BAMx Comments on PG&E’s Submission of Section 3.1 Material

The Bay Area Municipal Transmission group (BAMx)¹ appreciates the opportunity to comment on Pacific Gas and Electric Company’s (PG&E) June 1, 2020 submission of Section 3.1 Material for the Stakeholder Transmission Asset Review (STAR) Process on PG&E’s FERC-jurisdictional electric transmission projects, involving capital expenditures incurred over the past four years and/or anticipated to be incurred through the next five years.

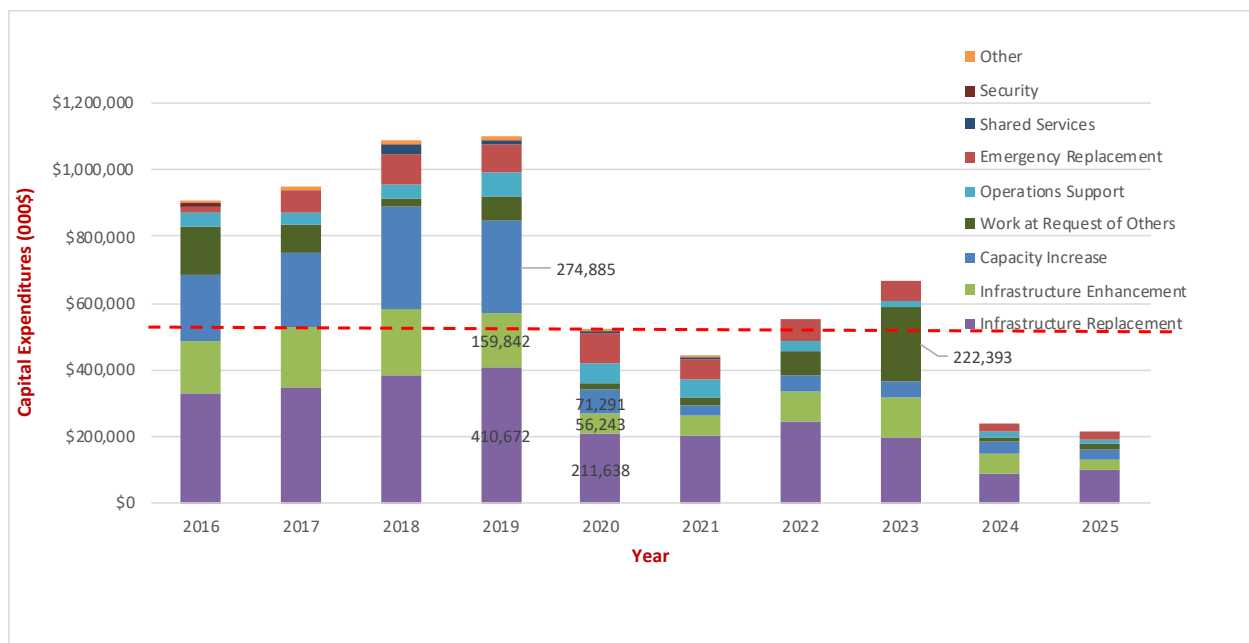
Based upon BAMx’s review of the Project Data Spreadsheet² provided by PG&E, we observe that PG&E’s future capital expenditure is substantially less than PG&E’s historical spending. The chart below summarizes our observation comparing 2020-2025 expenditures with what it has been for 2016-2019:

Question 1: We request PG&E to identify and explain in detail the key drivers for this apparent decline.³ Also, please identify whether there are any major new projects that PG&E now envisions that were not included in the Project Data Spreadsheet. We believe the STAR stakeholders need additional information from PG&E to better understand PG&E’s thinking and perspectives in structuring its capital expenditures (CapEx).

Need to Identify Criteria Applied to Determine Wildfire Mitigation Expenditures

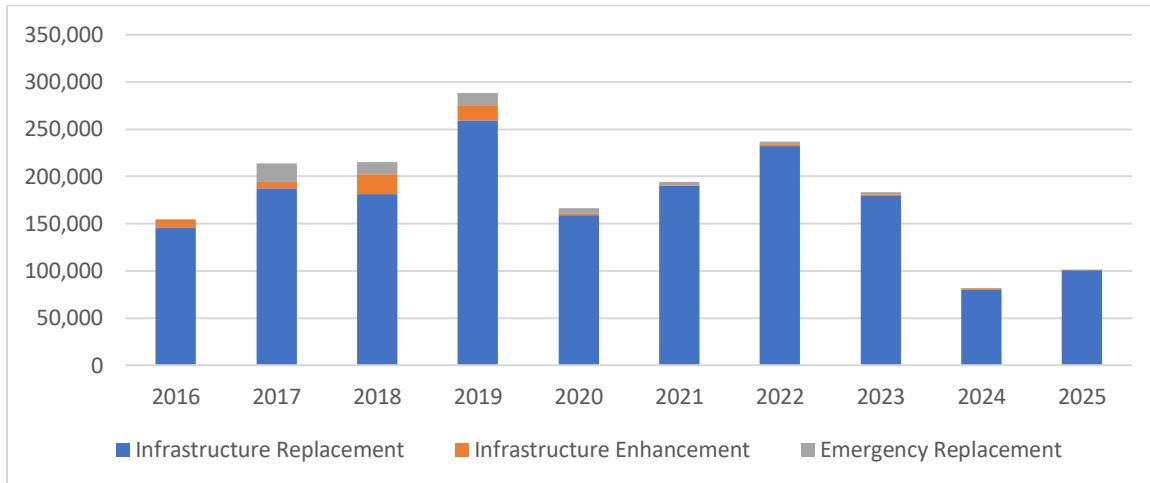
The Project Data Spreadsheet indicates that the projects related to transmission wildfire mitigation work amount to approximately \$200 million per year.

Question 13: It appears the majority of PG&E’s proposed transmission wildfire mitigation work is proactive equipment replacement based on age and condition. Please provide insights and supporting documentation, if any, as to the criteria applied for this work.

Question 14: Specifically, please describe in detail why PG&E is focusing the majority of its wildfire mitigation work on pole replacement, conductor replacement and Right of Way Access.
